Address: **5 BULLER STREET, NORTH PARRAMATTA**

Project: **PROPOSED BOARDING HOUSE DEVELOPMENT**

Report: **ACCESSIBILITY REPORT FOR DA SUBMISSION**

Reference: 210348 – Access Report

Clause	Comment	Status
<b>SECTION D: ACCESS AND EGRESS</b>		
	<p><u>Extract – Entrance pathway</u></p> 	
	<p><u>Extract – Internal Parts to Terrace</u></p> <p><u>Level 1</u></p> 	
	<p><u>Level 2</u></p>

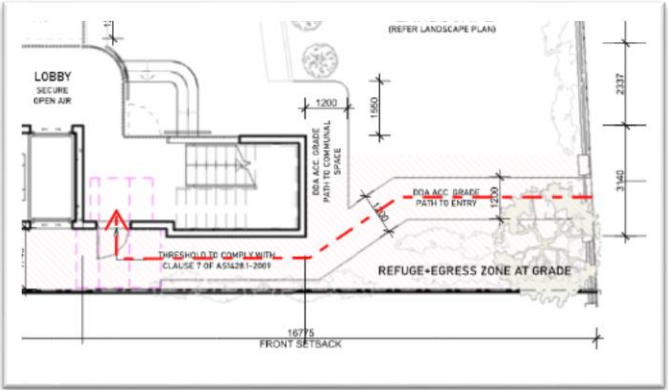
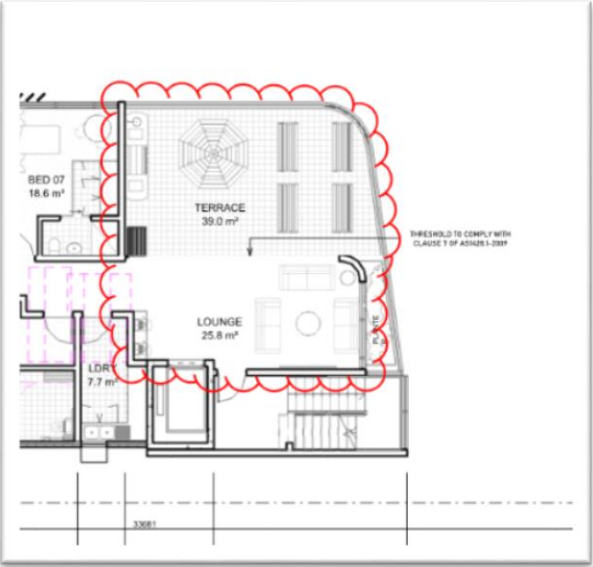
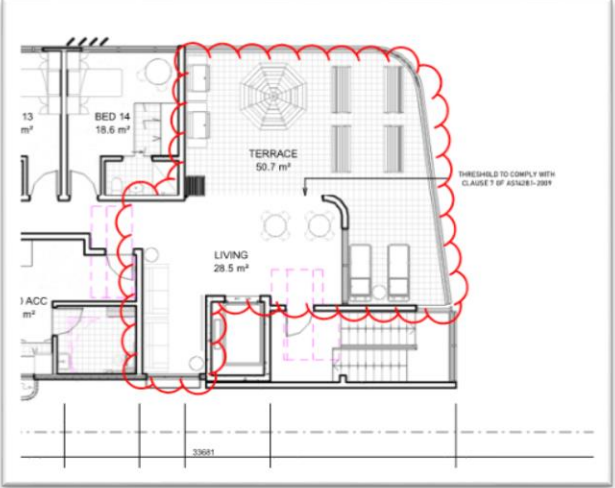
Clause	Comment	Status
<b>SECTION D: ACCESS AND EGRESS</b>		
<b>PART D3 - ACCESS FOR PEOPLE WITH A DISABILITY</b>		
D3.0: Deemed-to-Satisfy Provisions	<i>Noted</i>	-
D3.1: General Building Access Requirements	<p>Buildings or parts of buildings must be accessible as required below unless exempted under Clause D3.4.</p> <p>Accessible means having the features to enable use for persons with a disability.</p> <p><b>Class 3</b></p> <ul style="list-style-type: none"> <li>• All Common Areas (including storage areas/rooms);</li> <li>• Any external common landscaped areas or communal open spaces to at least one type, including any seating /eating /play /clothes-drying areas;</li> <li>• Common-use Laundry room</li> <li>• Common-use Garbage room (where accessible to residents);</li> <li>• Any proposed common accessible sanitary facilities;</li> <li>• All lifts;</li> <li>• Common-use store rooms to corridors;</li> <li>• To the entrance doorway of each sole-occupancy unit and to and within rooms or spaces for use in common by the residents located on the levels being served by the passenger lift;</li> <li>• To and within two (2) x accessible sole occupancy units.</li> </ul> <p><b>Comment:</b></p> <p>i. As per clause 7.2 of AS1428.1-2009 abutment of surfaces shall have smooth transition &amp; comprise of a slip resistant surface. Design transition shall be 0mm.</p> <p>Your attention is drawn to accessway (entrance pathway) from Buller Street and between internal parts of the building to "Terrace" areas on Level 1 and Level 2.</p> <p>It is acknowledged that a threshold ramp complying with clause 10.5 of AS1428.1-2009 has been nominated at each "Terrace area on Level 1 and Level 2. Relevant consultants to ensure compliance with AS4654.2-2012 is also maintained.</p> <p><i>(Continued on next page)</i></p>	<p>✓</p> <p>✓</p>

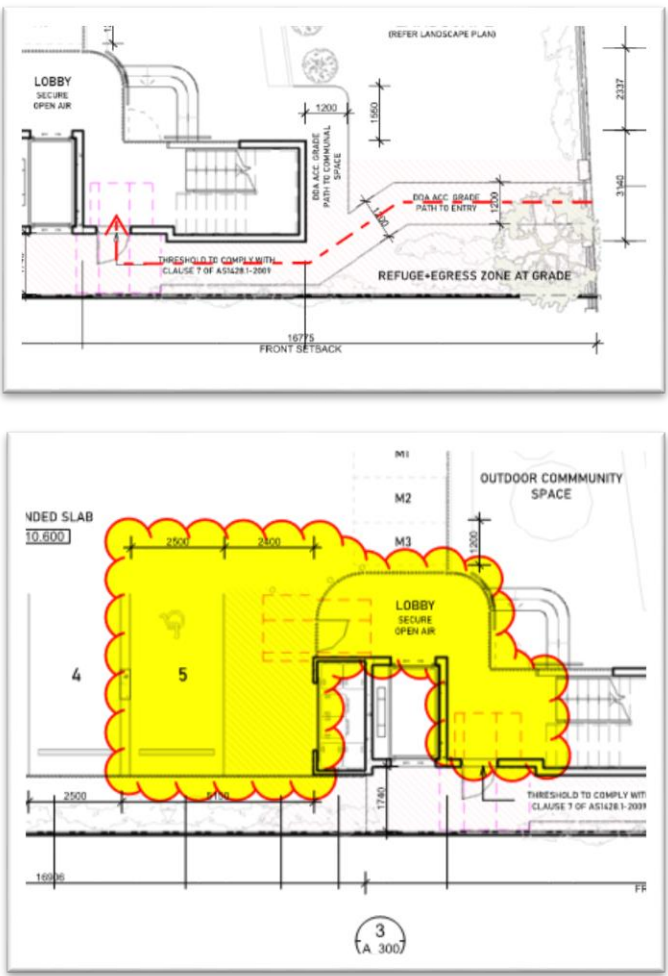
D3.2: Access to Buildings	<p>An accessway must be provided into the building from the main points of pedestrian entry at the allotment boundary and from any required accessible parking space on the allotment.</p> <p>In accordance with <b>clause 10.4 of AS1428.1-2009</b> please ensure the following is demonstrated at the CC stage:</p> <ul style="list-style-type: none"> <li>a) The gradient of curved ramps and walkways shall comply with Figure 20 of AS1428.1-2009.</li> <li>b) Landings shall comply with Clause 10.8 of AS1428.1-2009.</li> <li>c) The length of a curved ramp shall be measured horizontally along its <b>centre-line</b>.</li> <li>d) Curved ramps and walkways shall have a width of not less than 1500mm.</li> <li>e) Any crossfall shall be towards the centre of curvature.</li> </ul> <p>The principal pedestrian entrance and not less than 50% of all pedestrian entrances into the building must be accessible, (including the principal entrance).</p> <p>All required accessways are to comply with AS1428.1-2009.</p> <p><b>Your attention is also drawn to the need to comply with clause 7 of AS1428.1-2009 whereby the abutment of surfaces are required to achieve a design transition of 0mm.</b></p>	✓

Clause	Comment	Status
<b>SECTION D: ACCESS AND EGRESS</b>		
	 <p>The top drawing is a plan view of a lobby area labeled 'LOBBY SECURE OPEN AIR'. It shows a 'REFUGE+EGRESS ZONE AT GRADE' and a 'THRESHOLD TO COMPLY WITH CLAUSE 7 OF AS1428.1-2009'. Dimensions include 1200, 1950, 2337, 3340, 1370, and 16775. A note says 'REFER LANDSCAPE PLAN'. The bottom drawing is a plan view of an 'OUTDOOR COMMUNITY SPACE' with a yellow shaded area. It shows a 'THRESHOLD TO COMPLY WITH CLAUSE 7 OF AS1428.1-2009' and a '3 (A 3007)' detail. Dimensions include 2500, 2500, 2500, 1780, and 16900.</p>	
	<b>Details of compliance to be submitted to nominated PCA at CC stage.</b>	
D3.3: Parts of Buildings to be Accessible	<p>Ramps, stairways, walkways, circulation spaces at doorways, door widths and accessible paths comply with AS1428.1-2009.</p> <p>Every ramp and stairway, except for ramps and stairways in areas exempted by clause D3.4 of the BCA, must comply with—</p> <ol style="list-style-type: none"> <li><b>for a ramp, <u>except a fire-isolated ramp</u>, clause 10 of AS 1428.1 ; and</b></li> <li><b>for a stairway, <u>except a fire-isolated stairway</u>, clause 11 of AS 1428.1; and</b></li> <li>The fire isolated stairways will need to comply with Clause 11.1(f) and (g) of AS1428.1-2009 which requires each tread to have a luminance contract strip which can be detailed on design documentation at the construction certificate stage. The fire-isolated stairways are required to have a handrail that maintains a 270-degree clearance for a continuous handhold in accordance with Clause 12 of AS1428.1-2009.</li> </ol> <p><b>Every passenger lift must comply with E3.6 - See compliance commentary below.</b></p>	✓

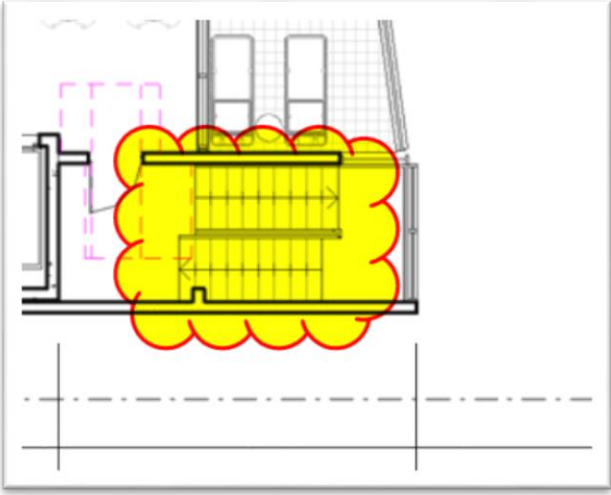
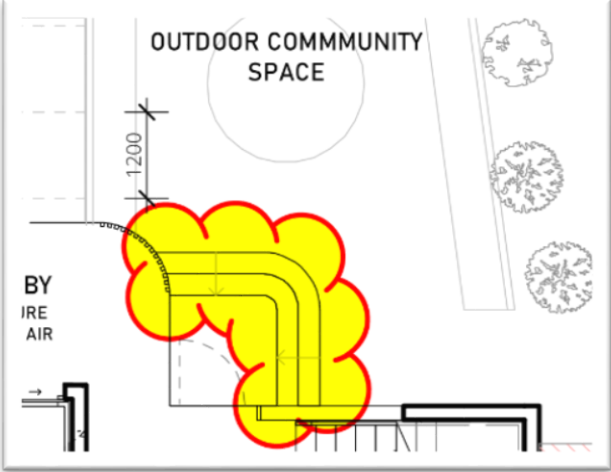
Clause	Comment	Status
<b>SECTION D: ACCESS AND EGRESS</b>		
	<p>Latch side clearance on <u>front approach</u> from car park side is not being achieved and latch side clearance from lobby side also does not comply per Figure 31 of AS1428.1-2009. Refer to Appendix B9 for clearance requirements from each approach side of door leaf.</p> <p>b. <u>Stairway</u></p> <p>Each nominated common stairway is required to achieve compliance with clause 11 of AS1428.1-2009. Refer to Appendix B for further information.</p> <p><i>Extract 1 - Example: non-isolated serving each storey</i></p>  <p>Stairway <u>does not</u> currently indicate any:</p> <ul style="list-style-type: none"> <li>Tactile Ground Surface Indicators (TGSIs) as per AS1428.4.1-2009</li> <li>Handrail terminations as per Figure 26(C) and 26(D) of AS1428.1-2009</li> </ul> 	<p>✓</p> <p>✓</p>

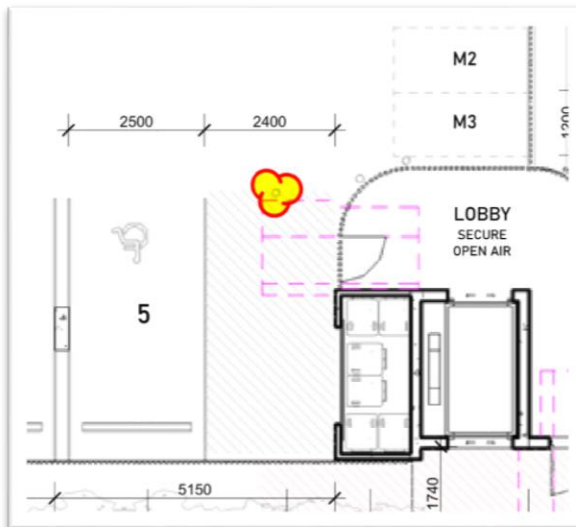
Clause	Comment	Status
<b>SECTION D: ACCESS AND EGRESS</b>		
	<p><b>Extract 2: Stairway serving the “Outdoor Community Space”</b></p> <p>Stairway <u>does not</u> currently indicate any:</p> <ul style="list-style-type: none"> <li>Tactile Ground Surface Indicators (TGSIs) as per AS1428.4.1-2009</li> <li>Handrail terminations as per Figure 26(C) and 26(D) of AS1428.1-2009</li> </ul> <p>Details of compliance to be submitted to nominated PCA at CC stage.</p>	
D3.4: Exemptions	<p>The following areas in the proposal are considered to not be accessible due to specific uses of the room or space:</p> <ul style="list-style-type: none"> <li>‘LDRY’ room on Level 1</li> <li>‘Garbage Store’ on Ground Floor</li> </ul>	<i>Noted</i>
D3.5: Accessible Car Parking	<p>One (1) Accessible car parking space must be provided in accordance with Table D3.5 of the BCA in the <b>Class 7a part (carpark)</b> to comply with AS/NZS 2890.6.</p> <p><b>Comment</b></p> <p>In accordance with the BCA, One (1) Accessible car parking space must be provided.</p> <p>The current nominated accessible parking space <u>does not</u> comply with the requirements of AS/NZS 2890.6-2009 (Off-street parking for people with disabilities) due to bollard location not being in a complying location in accordance with Detail B.12 within Annexure B of the report.</p> <p>It is acknowledged that compliance may be difficult to be achieved due to encroachment/clash into circulation spaces at doorways as per Figure 31 of AS1428.1-2009.</p>  <p>Should a deemed –to-satisfy solution not be proposed, an Access Related Performance Solution is to be provided to the assigned PCA at CC Stage.</p>	<b>X</b>

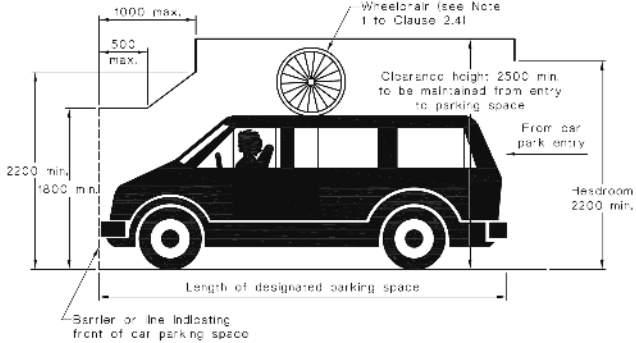
Clause	Comment	Status
<b>SECTION D: ACCESS AND EGRESS</b>		
	<p><b>Finally, ensure headroom above car space for people with disabilities is achieved in accordance with AS/NZS 2890.6.</b></p>  <p>DIMENSIONS IN MILLIMETRES</p> <p>FIGURE 2.7 HEADROOM REQUIRED ABOVE CAR SPACES FOR PEOPLE WITH DISABILITIES</p> <p><b>It is the author opinion that traffic engineer input is required to ensure turning circle is achieved.</b></p>	
D3.6: Signage	Braille and tactile signage complying with Specification D3.6 and incorporating the international symbols as appropriate must identify each sanitary facility and all accessible entrances where an entrance is not accessible.	✓
D3.8: Tactile Indicators	<p>(a) For a building required to be accessible, tactile ground surface indicators must be provided to warn people who are blind or have a vision impairment that they are approaching—</p> <ul style="list-style-type: none"> <li>(i) a stairway, other than a fire-isolated stairway; and</li> <li>(ii) an escalator; and</li> <li>(iii) a passenger conveyor or moving walk; and</li> <li>(iv) a ramp other than a fire-isolated ramp, step ramp, kerb ramp or swimming pool ramp; and</li> <li>(v) in the absence of a suitable barrier— <ul style="list-style-type: none"> <li>(A) an overhead obstruction less than 2 m above floor level, other than a doorway; and</li> <li>(B) an accessway meeting a vehicular way adjacent to any pedestrian entrance to a building, excluding a pedestrian entrance serving an area referred to in D3.4, if there is no kerb or kerb ramp at that point, except for areas exempted by D3.4.</li> </ul> </li> </ul> <p><b>(b) Tactile ground surface indicators required by (a) must comply with sections 1 and 2 of AS/NZS 1428.4.1.</b></p> <p>(c) A hostel for the aged, nursing home for the aged, a residential aged care building, Class 3 accommodation for the aged, Class 9a health-care building or a Class 9c aged care building need not comply with (a)(i) and (iv) if handrails incorporating a raised dome button in accordance with AS/NZS 1428.4.1 are provided to warn people who are blind or have a vision impairment that they are approaching a stairway or ramp.</p> <p><b>Comment</b></p> <p><b>Your attention is drawn to the non-isolated stairway serving each storey &amp; stairway leading to “outdoor community</b></p>	✓
